Advanced Technology Centre, Vale of Glamorgan

Transport Assessment Addendum 2

2.0 Response to VoGC Highways Comments (dated 16th August 2024)

3.0 Response to Link Transport Planning Final TAA Review (dated 12th August 2024)

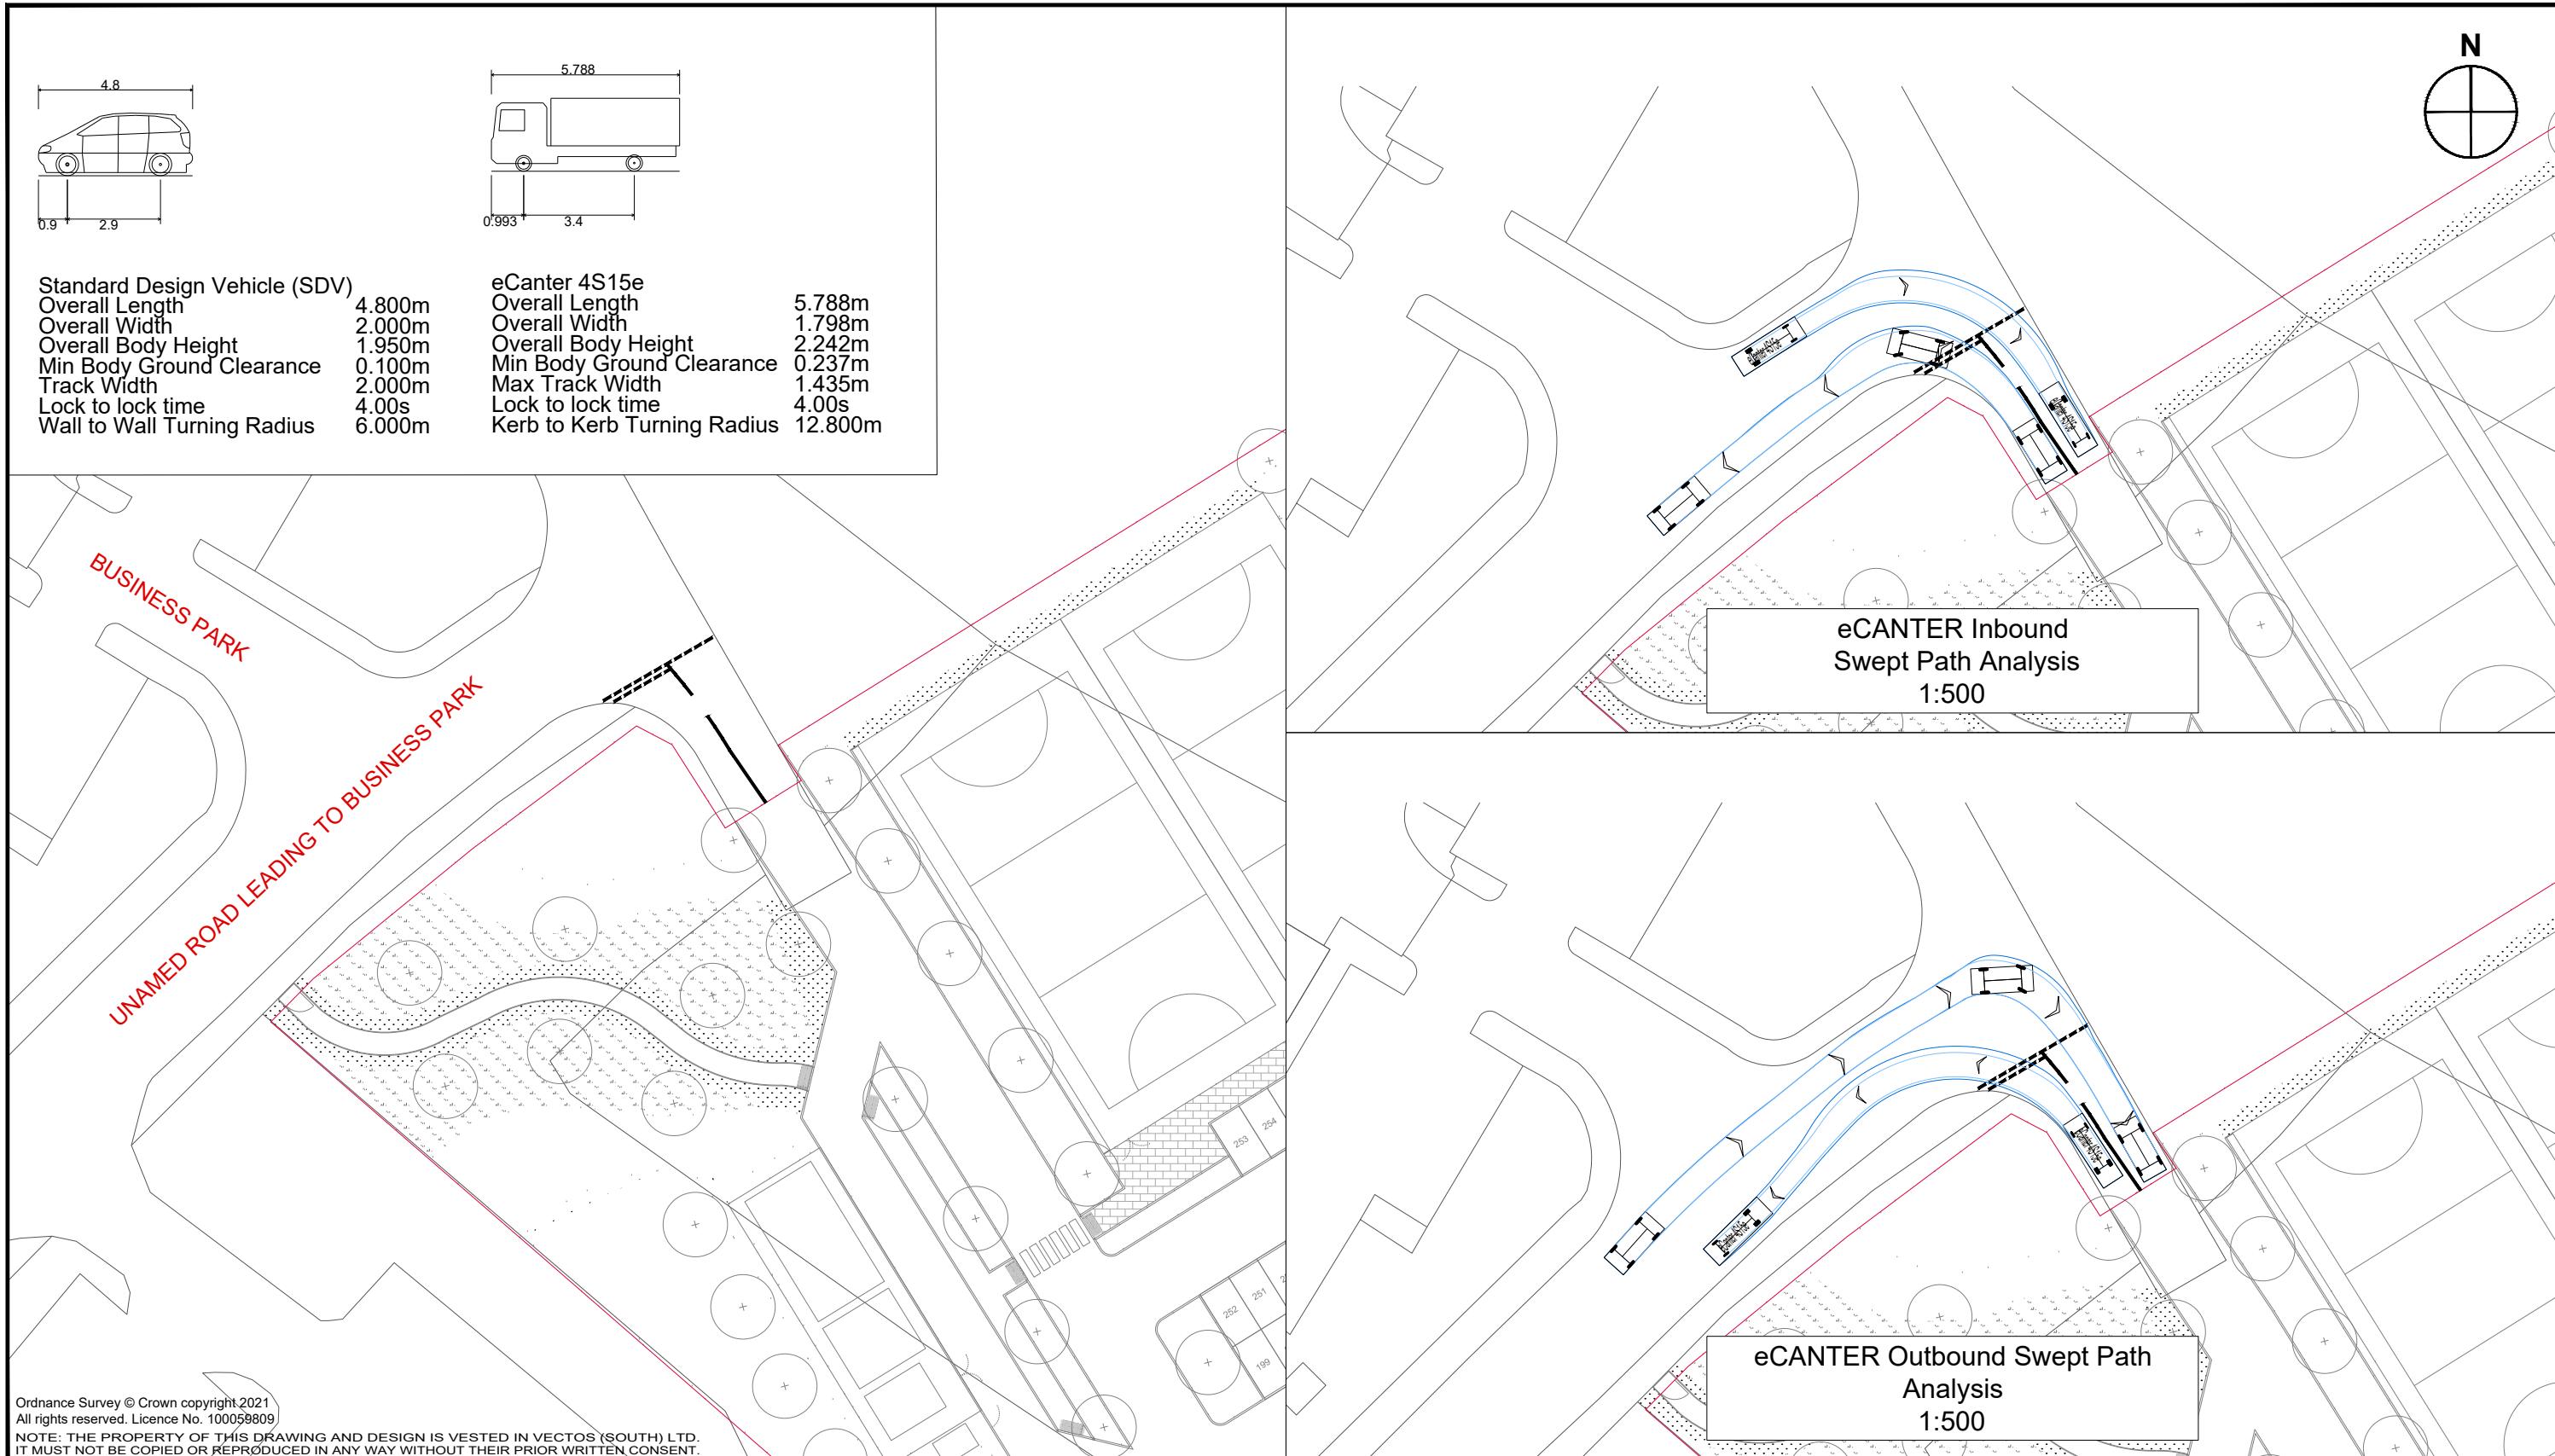
LTP Reference	LTP Comment	SLR Response
		during the day, thus internalising some trips that would otherwise take place.
Revised Recommendation 3	The original recommendation stands. The proposed new bus stop is intended to cater for CAVC Rider services. Staff and pupils arriving via public services will use existing infrastructure which may require upgrading to encourage bus use.	The proposed new bus stop on Port Road is intended to cater for existing public services as well as any future services proposed by CAVC. The existing bus stops on Port Road therefore do not require any upgrading to encourage bus use.
Revised Recommendation 4	The refuse vehicle tracked is suitably addressed. However, VoGC needs to consider whether there is a likelihood that vehicles larger than an 11.2m refuse vehicle will be required to service the site. For example, 12m rigid deliveries or larger articulated vehicles.	CAVC has confirmed that the 11.2m refuse vehicle will be the largest vehicle to access the site. However, they have advised that an eCanter truck would be required to access the site. Swept path analysis has been undertaken for this vehicle, as included at Appendix A .

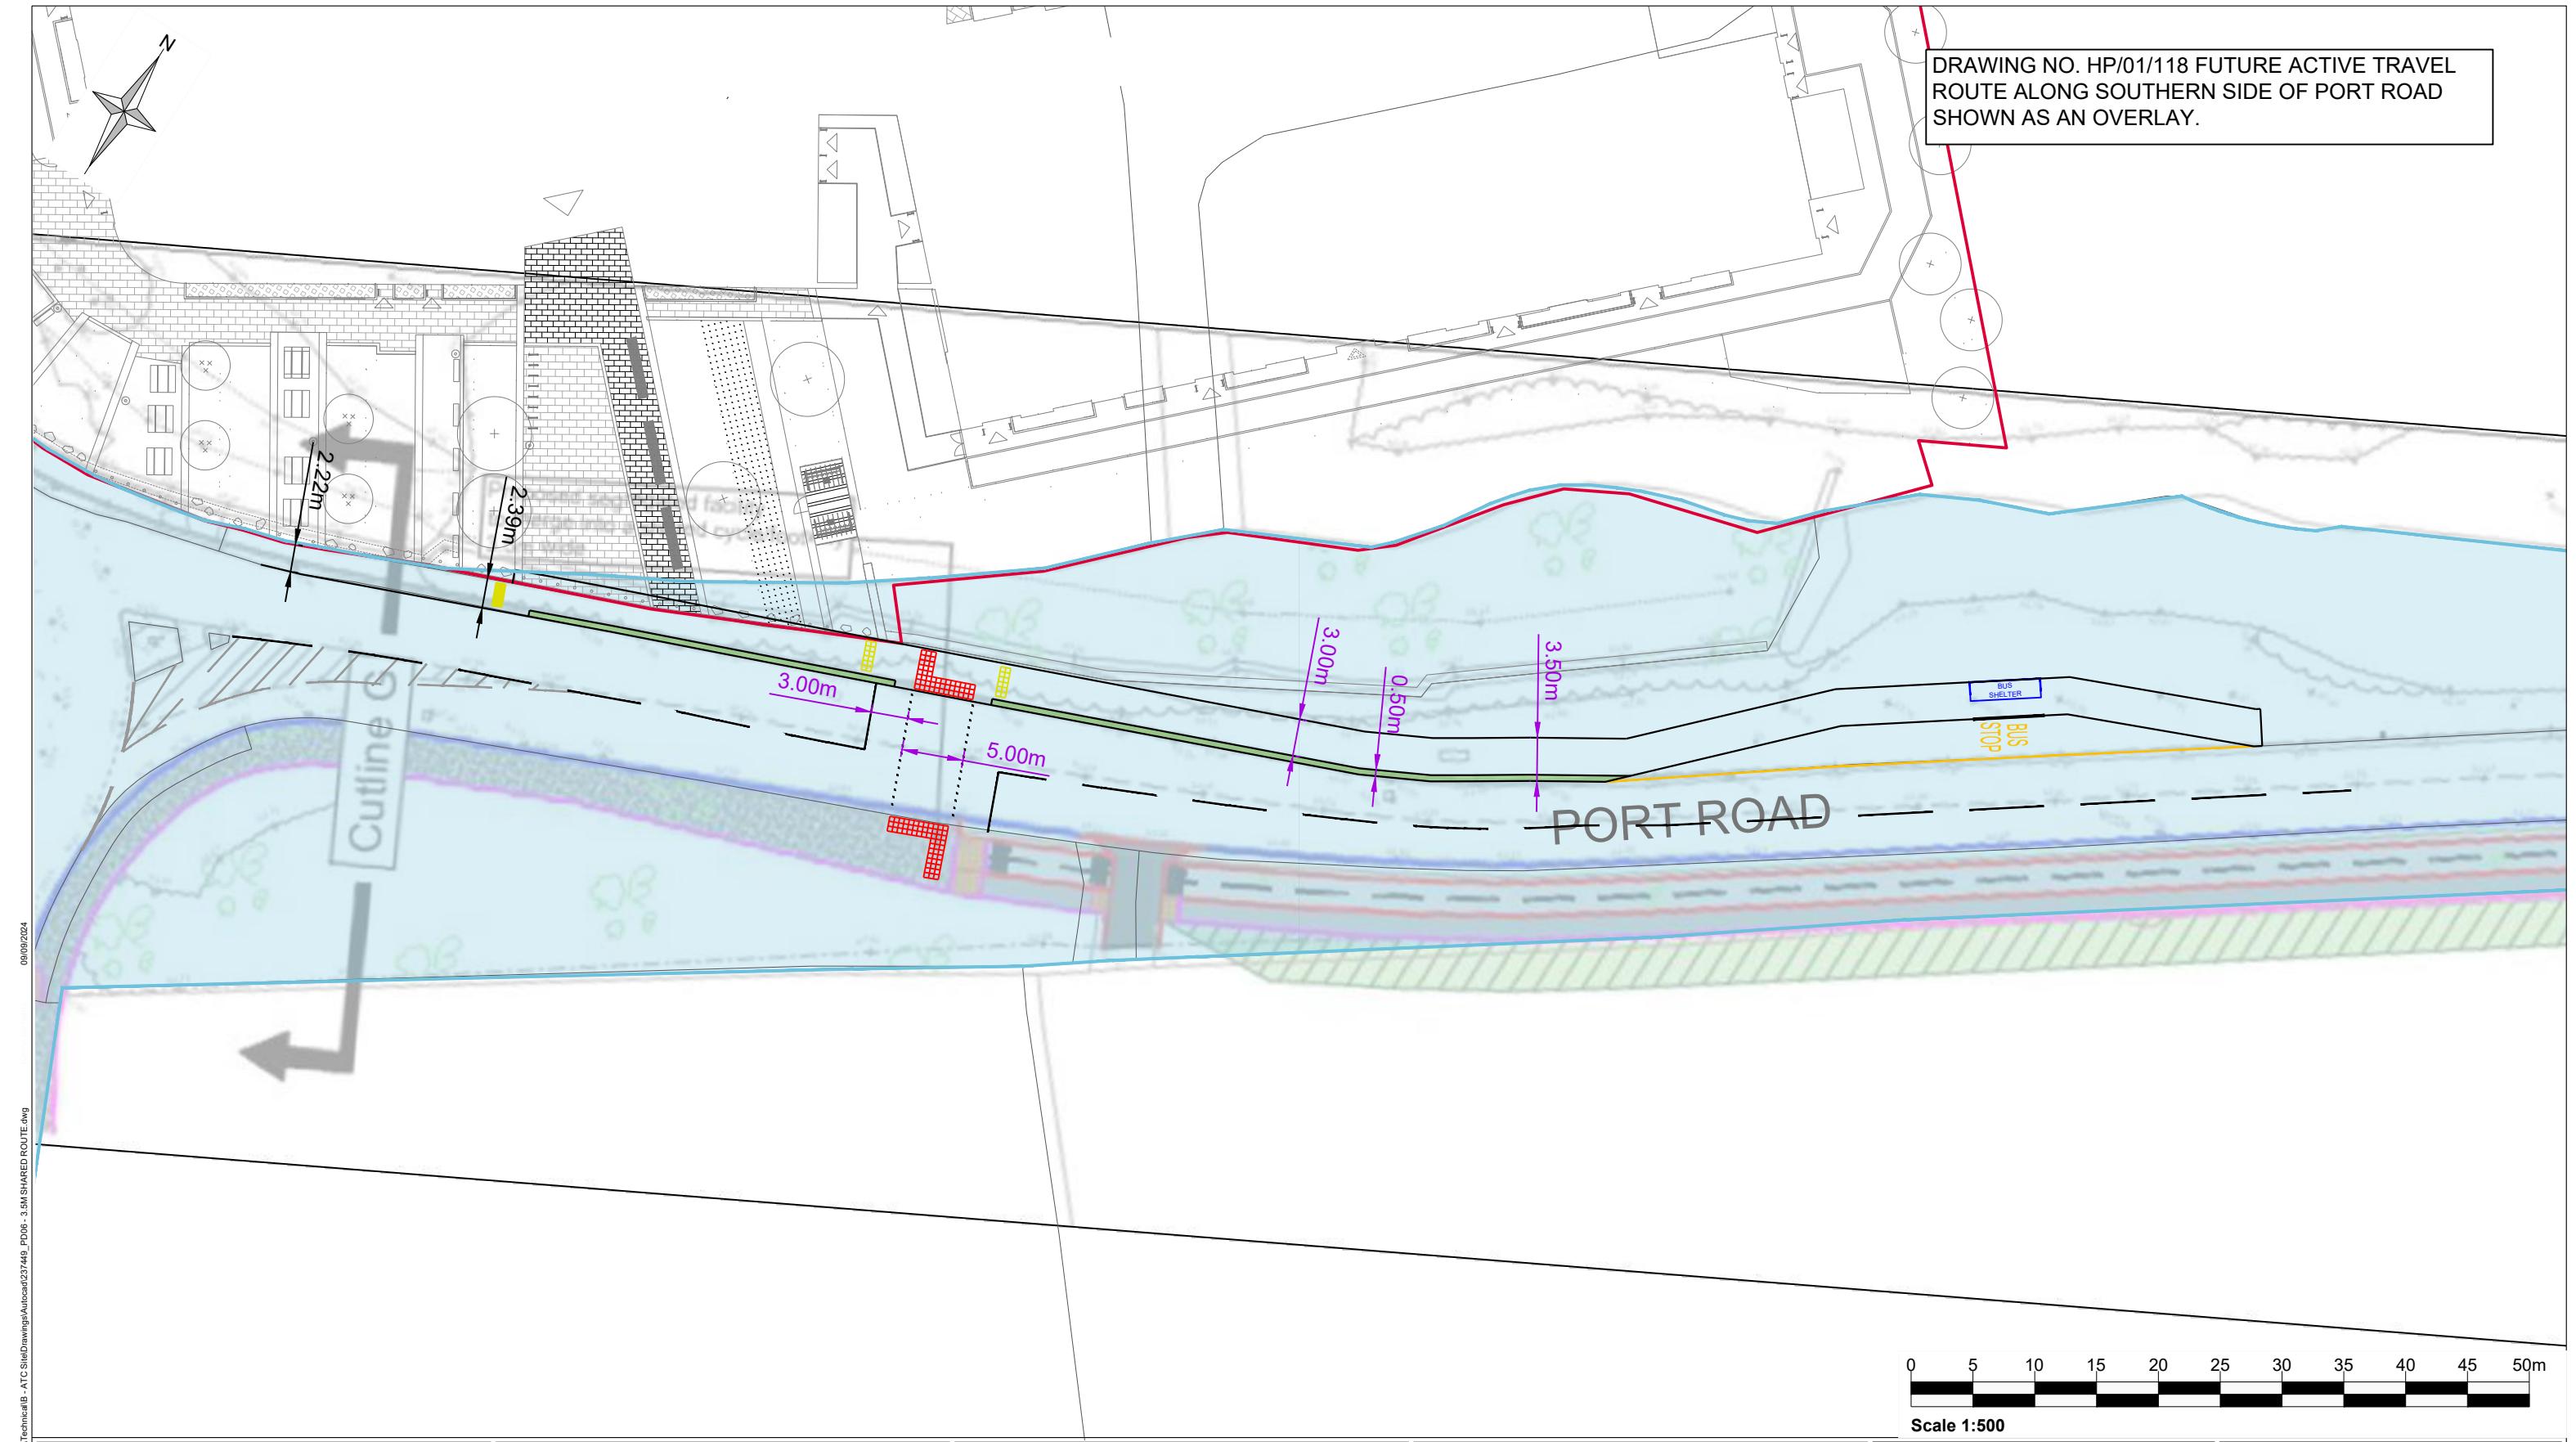
- 2.3 The active travel route proposed along the site frontage is sub-standard in terms of widths and proximity to a 50mph road and falls short of all AT Acts requirements. Furthermore, the route does not connect directly to all accesses of the college rendering it superfluous for transporting cyclists to the site.

Revised Recommendation 8	<p>The original recommendation has not been addressed and it is considered that the provision of an active travel link between the site and the existing shared use provision on Port Road/Porthkerry Road is an essential requirement that is directly related to the development as it will improve connections between the site and Rhoose railway station.</p> <p>With reference to the comment of it not being a reasonable request, key aspects of Planning Policy Wales Edition 12 are provided below [emphasis added by Link Transport Planning]:</p> <p>Para 4.1.30 states that: 'New development places additional demand on transport infrastructure and networks,</p>	<p>Through subsequent discussions with VoGC on Friday 6th September and Tuesday 10th September, it has been agreed that the provision of an active travel link between the site and the existing shared use provision on Port Road/Porthkerry Road is not required.</p> <p>Part of the route (between Port Road and Porthkerry Road) is included in VoGC's proposals for a future active travel route between Weycock Cross and Cardiff Airport. VoGC has advised that Phase 1 of the route (between Weycock Cross and the Dragon's Tail roundabout) is due to be constructed in the 2025/2026 financial year. Phase 2 of the</p>

- 2.4 It is now proposed to provide a 3.5m active travel route on Port Road along the site frontage. This will provide a route to the proposed new bus stop to the east of the site and an active travel access to the main entrance to the site from Port Road for pedestrians and cyclists.

2.10 In our most recent discussions with VoGC highways officers, it has been advised that Phase 2 of the route could be constructed by April 2027. A Toucan crossing has also been requested on Port Road to provide a link between the proposed active travel route along the site frontage, and the future active travel route on the southern side of Port Road to be delivered by others.

LTP Reference	LTP Comment	SLR Response
	<p>with the location, layout and design of development affecting the distance and way in which people travel.</p> <p>Developing local active travel networks can help to mitigate the impact of new development, by providing an alternative mode of travel to the private car, particularly for shorter journeys.</p> <p>Provision for active travel must be an essential component of development schemes and planning authorities must ensure new developments are designed and integrated with existing settlements and networks, in a way which makes active travel a practical, safe and attractive choice.</p> <p>Para 4.1.31 states that: 'Planning authorities must support active travel by ensuring new development is fully accessible by walking and cycling...'</p> <p>Para 4.1.33 states that: 'New development should be integrated with active travel networks and contribute to their expansion and improvement, through the inclusion of well-designed routes and facilities as part of the schemes and financial contributions to pay for off-site connections.'</p> <p>Para 4.1.34 states: 'In determining planning applications, planning authorities must ensure development proposals, through their design and supporting infrastructure, prioritise provision for access and movement by walking and cycling and, in doing so, maximise their contribution to the objectives of the Active Travel Act.'</p>	<p>route (from Dragon's Tail roundabout to Port Road/Porthkerry Road roundabout) is due to be constructed in the 2026/2027 financial year.</p> <p>In order to improve access to the site by active travel modes, it is proposed to provide an active travel link along the site's frontage on Port Road and a Toucan crossing to link to the future active travel link proposed by VoGC on the southern side of Port Road to the main entrance plaza to the ATC site. The proposed works are located within existing adopted highway and are capable of delivery as off-site highway works under the Highways Act. This is demonstrated in Appendix C.</p>
